PAGODA &  
HERON TOWERS

EDG Meeting #2  
DPD #3008492  
February 12, 2008

## DESIGN GUIDELINES COMMENTS: (FROM DECEMBER 11, 2007 EDG MEETING)

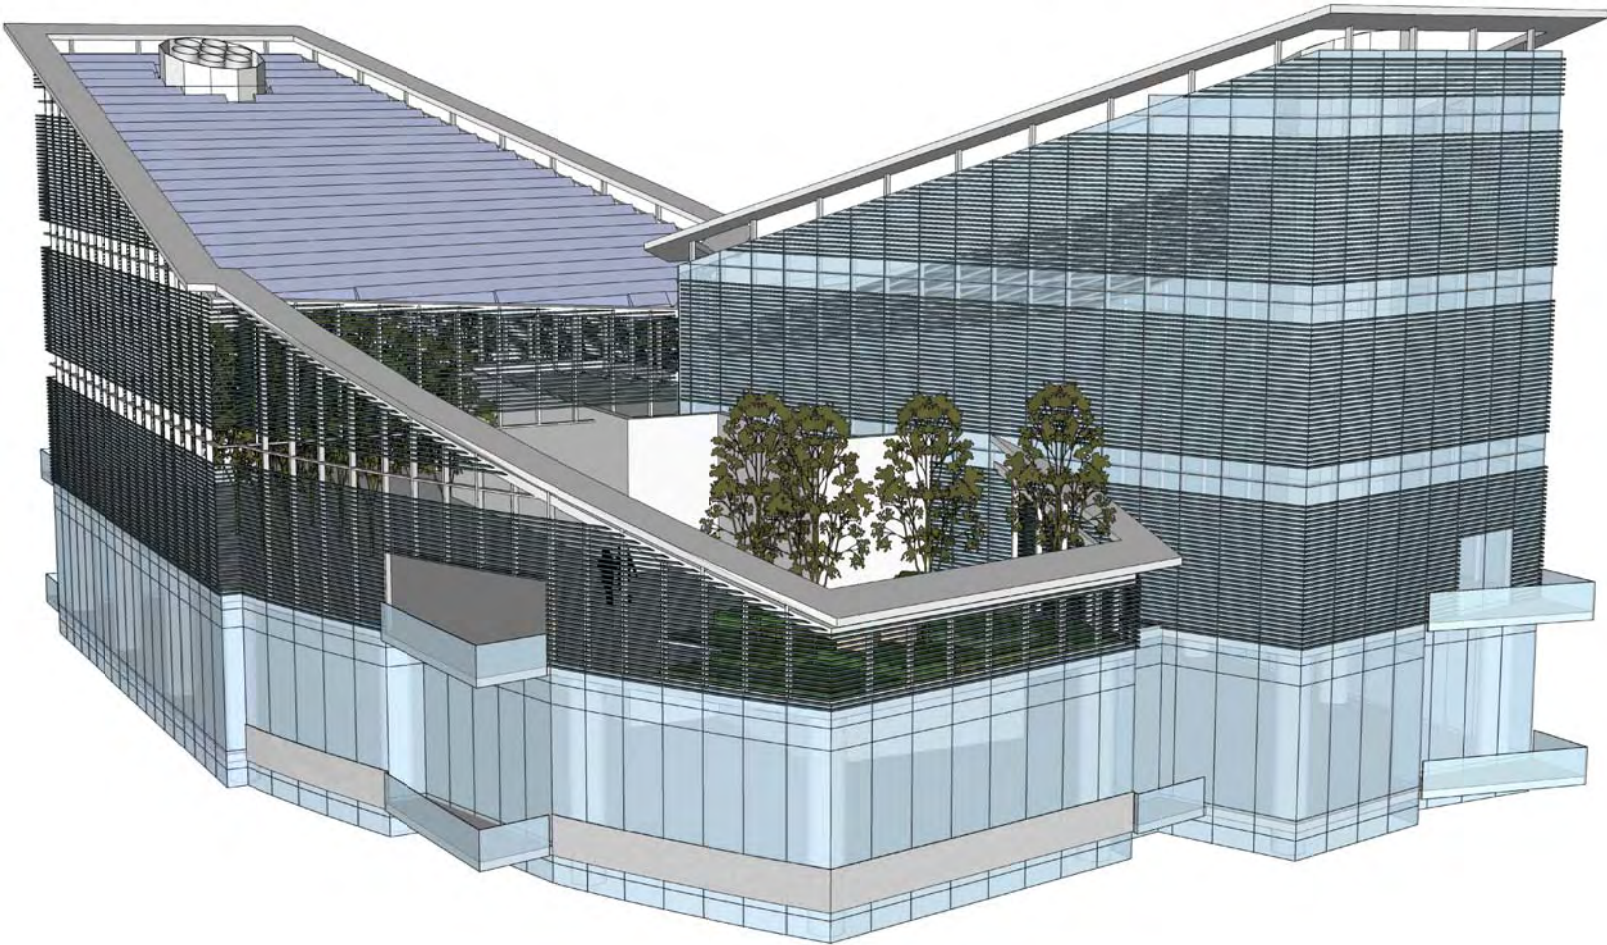
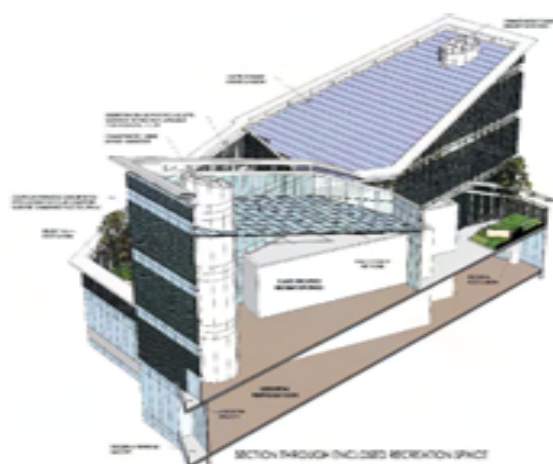
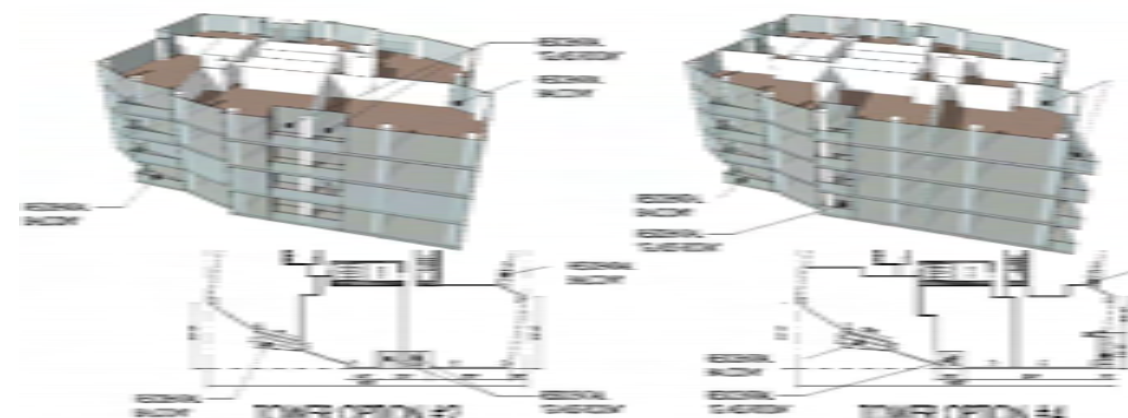
**A-1** STUDY THE DESIGN OF THE BASE STRUCTURE THAT PICKS UP THE TEXTURE OF THE STRUCTURES IN THE IMMEDIATE NEIGHBORHOOD.

**A-2** DEVELOP THE OPPOSING ROOF STRUCTURES AS SHOWN ON P48

*See pp:19-23, 25-27 and 34-35 for studies of the immediate neighborhood and base texture.*

*See pp:38-42 for the development of the opposing roof structures.*

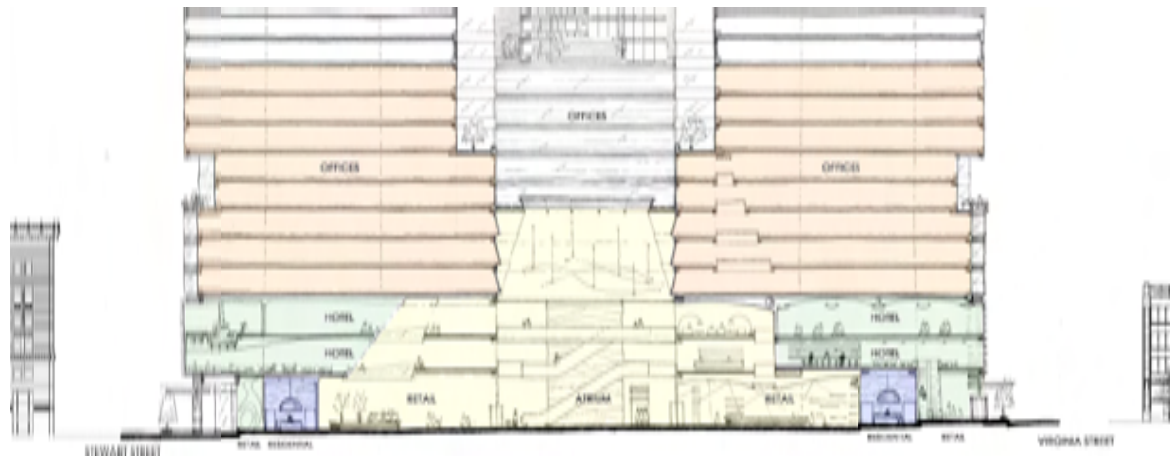
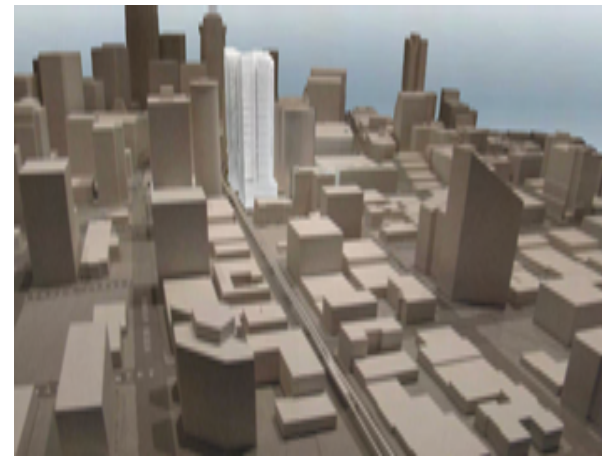
**B-4** THE OUTWARD EXPRESSION OF INTERNAL FUNCTIONS IS POSITIVE. THE BOARD AGREED THAT THE PROPOSED OFFICE COMPONENT IN SCHEME 3 BETWEEN THE TWO TOWERS SEEMS ALIEN TO THE PROJECT (PP.34, 37, 43) AND CONTRADICTS THE THIN VERTICALITY OF THE TOWERS. THE BASE OF SCHEME 2 APPEARS MORE APPROPRIATE AND CLEAR WITH THE 5 READABLE DIVISIONS ALONG THE STREET. (P.32)

**C-3** CONSIDERATION OF THE ESCALA'S PROXIMITY AND OF THE ARCHITECT'S TREATMENT OF THE ALLEY FAÇADE IS CRITICAL TO THE BOARD'S REVIEW.

*See p: 18 and 25-27 for revised building massing emphasizing the verticality of the towers and 29, 30, 32-35 for outward expression of internal functions.*

*See pp: 10, 12, 13 and 24 for Escala's proximity and p: 35 for the Alley facade.*
